PRODUCT CHANGE NOTICE

PCN#23-041**NOTIFICATION DATE: June 2, 2023****MODELS AFFECTED****ZN3PD-02183-S+****EXTENT OF CHANGE:**

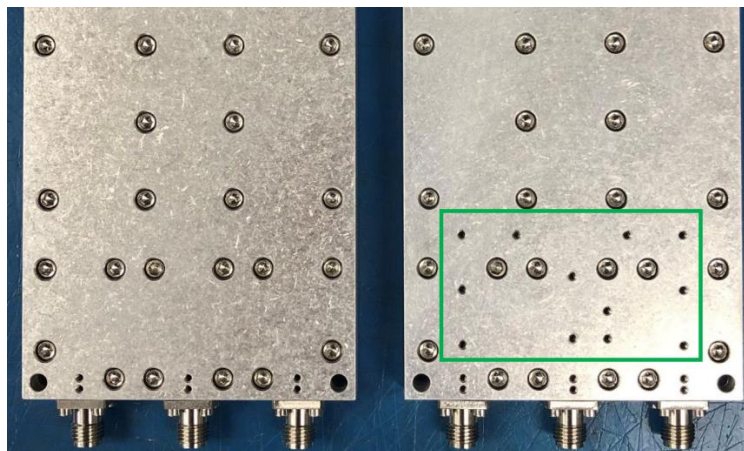
Addition of tuning holes to achieve consistent spec performance (see Green Box image below)

No change to FIT (Dimensions) or Function (Performance)
Change to FORM (Appearance)

Improved consistency of performance, No change to specification
